Declaration

Product Name: Digital Video Recorder

Model No.: DVT5201

FCC ID:YGB-DVT5201

图 1

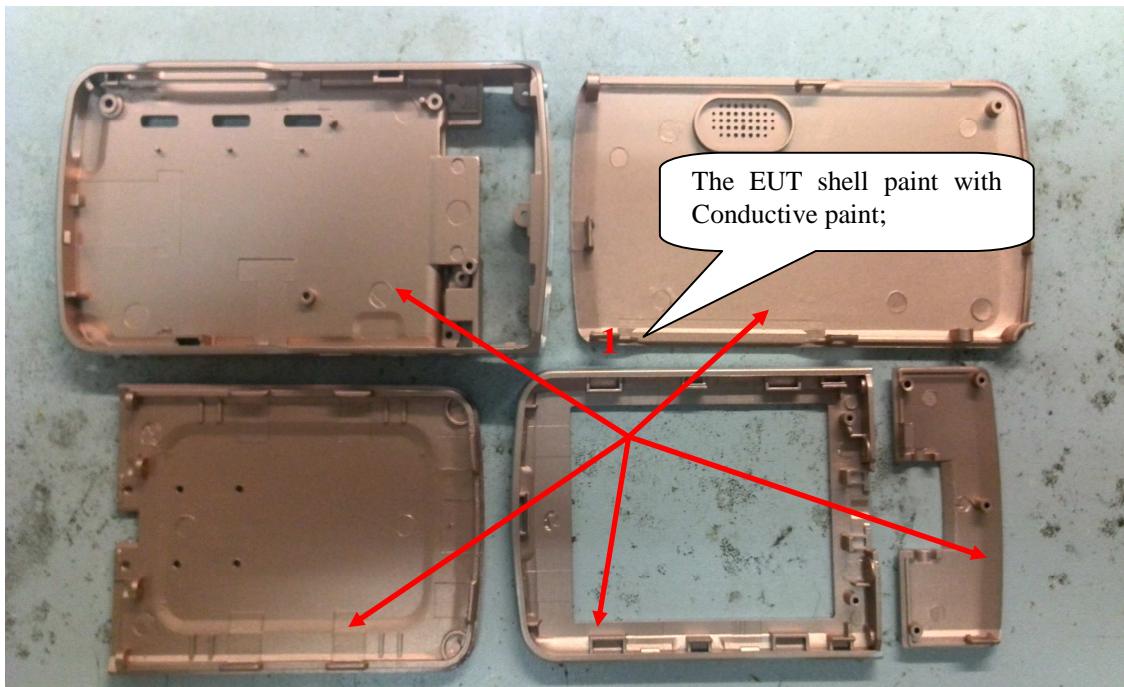
1. The EUT shell paint with Conductive paint.
2. The USB cable should add a core and shielding.
3. R23 and R34 need change to 220ohm,R8 and R10 need change to bead (model: BEAD0603H301T).
4. PCB should add a piece of copper grounding , the copper size is 35*35(mm).
5. R29 and R31 need change to 220ohm, L2 need change to bead (model: BEAD0805S102A10T).
6. Connect main PCB GND and Sensor PCB GND.
7. PCB should add a piece of copper grounding, the copper size is 32*38(mm), and add a piece of Conductive foam for connecting the coper to shielding shell.
8. R106 and R111 need change to 470ohm.
9. The LCD cable need change to shielding cable, and both ends connect to GND.
- 10.Cancel the AV output function.
